Sea Link

Document 9.73: Applicant's Responses to First Written Questions

Planning Inspectorate Reference: EN20026

Version: A
January 2026

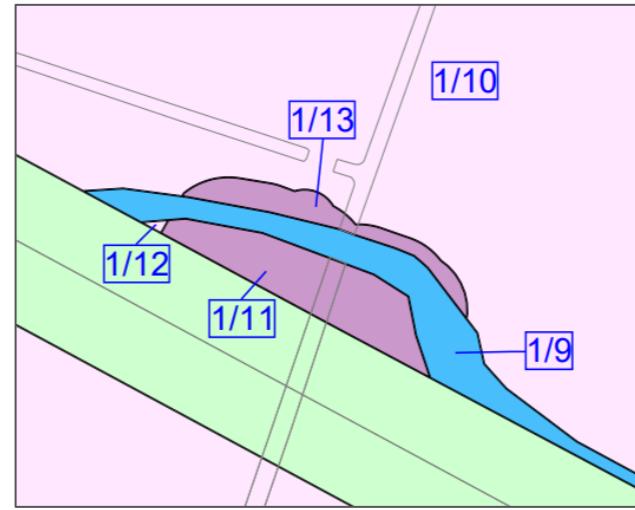
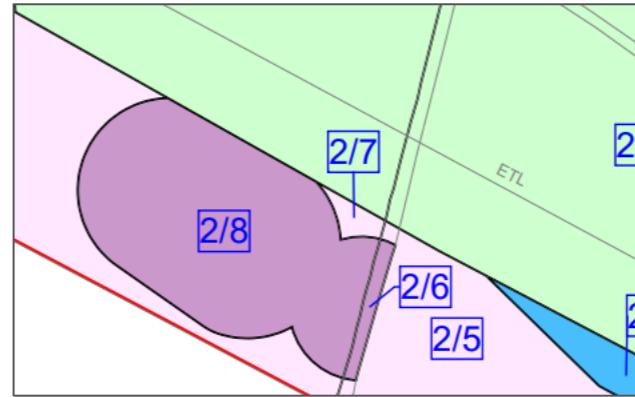
1GEN78.	Applicant	<p>Clarification regarding Suffolk plots 1/4 and 1/7</p> <p>Suffolk plot 1/4 is identified for class 6 CA of rights (drainage) for work no. 3A access road to the converter station and Suffolk Plot 1/7 is identified for class 5 CA of rights (access) for work no 3A access road to the converter station. However, these plots both appear to relate to the temporary construction compound rather than the access road.</p> <p>Provide an explanation as to why these plots are required and for which work no and update any core documents as necessary.</p>

Reference	Question to:	Question	Applicant's Response
			Suffolk Plot 1/4 is shown as Class 6 for Drainage (CA) on the Land Plans and Work No.13 for drainage on the Works Plans. This reflects the drainage required around the compound.
			Suffolk Plot 1/7 is shown as Class 5 for Access (CA) on the Lands Plans and Work No 14 for access on the Works Plans. The is land between the permanent access to the converter station into the compound.
			The drainage and access shown in Plot 1/4 and Plot 1/7 respectively are for the construction compound, rights for which are being requested such that the compound can be reinstated in the future to enable maintenance or demolition works to be undertaken. A decision was taken to retain the Suffolk compound (plot 1/9) as a permanent compound right (class 4). The DCO is intended to consent the life of the project and therefore there is a need to provide a future compound for large scale maintenance works during the operational life of the converter station and decommissioning. The retained right for a permanent compound will also serve as a location for works to the permanent access road and bridge over the River Fromus, to accommodate the lifetime of the scheme. An example of maintenance would be replacing the transformers which are transported by AIL. These need to be stored securely whilst the old ones are removed prior to transportation.

Figure 1LVI A8 – 1 Typical cross section through Order Limits along B1119

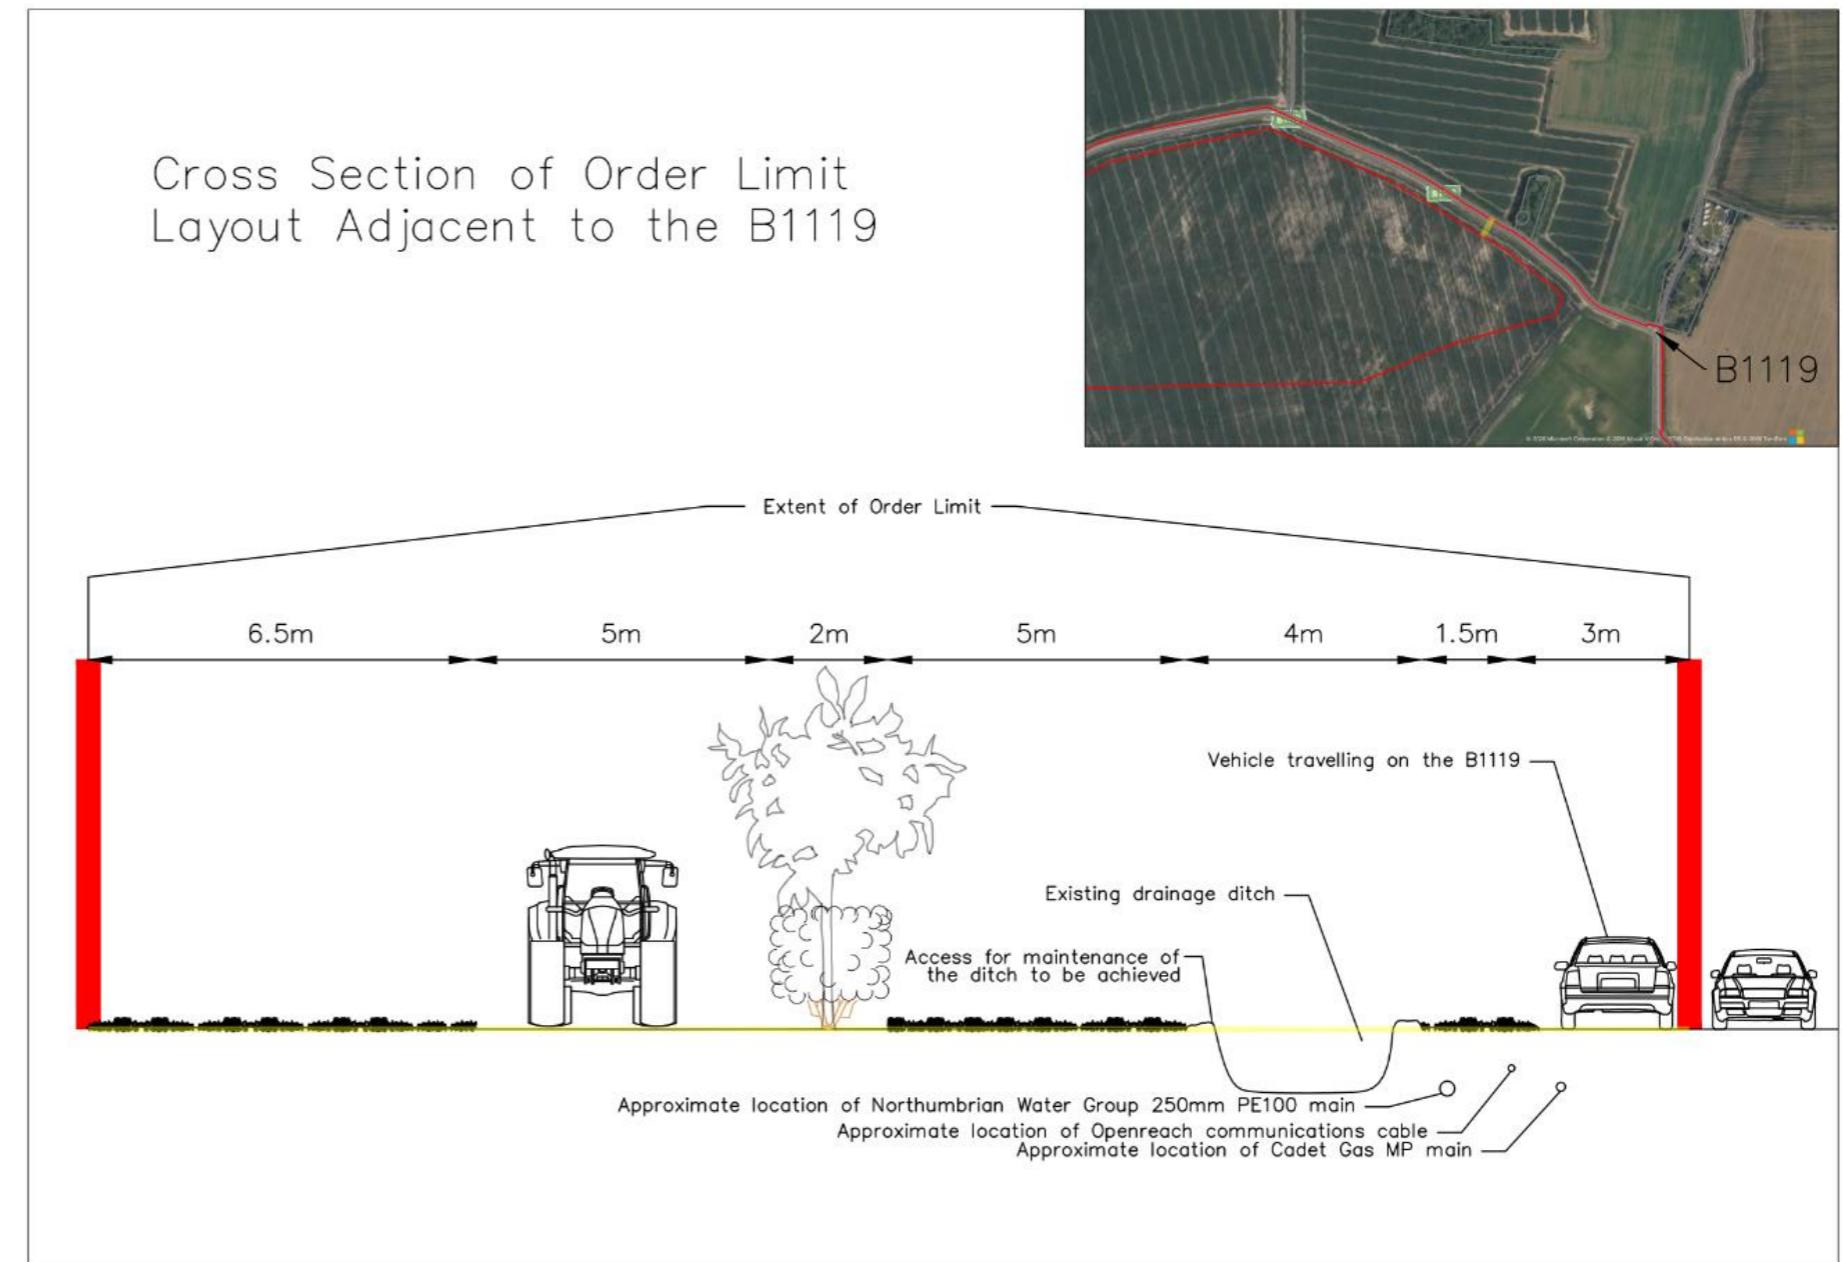
1LVIA8.	Applicant	Landscape mitigation for Saxmundham converter station The landscape planting alongside the B1119 is not very clearly shown in relation to the order limits, nor is it clear the extent to which it would consist of hedgerow or trees. Provide a more detailed explanation as to whether the planting includes structural landscape planting that would be capable of integrating the converter station into the existing landscape in longer range views.	Figures 1LVIA8 – 1 and 2 below shows typical cross sections through the Order Limits along the B1119 north of the proposed Saxmundham Converter Station and north of the Christmas tree fields respectively. The arrangements shows that there is sufficient space available for maintenance of the hedgerow from both sides as well as access for maintenance of the drainage ditch from the non-trafficked side. Additional width is provided within the cross section to the north of the converter station (Figure 1LVIA8 – 2) to enable flexibility in the landscaping to allow for the temporary PRoW diversion and to allow for any utility changes required for connection works.
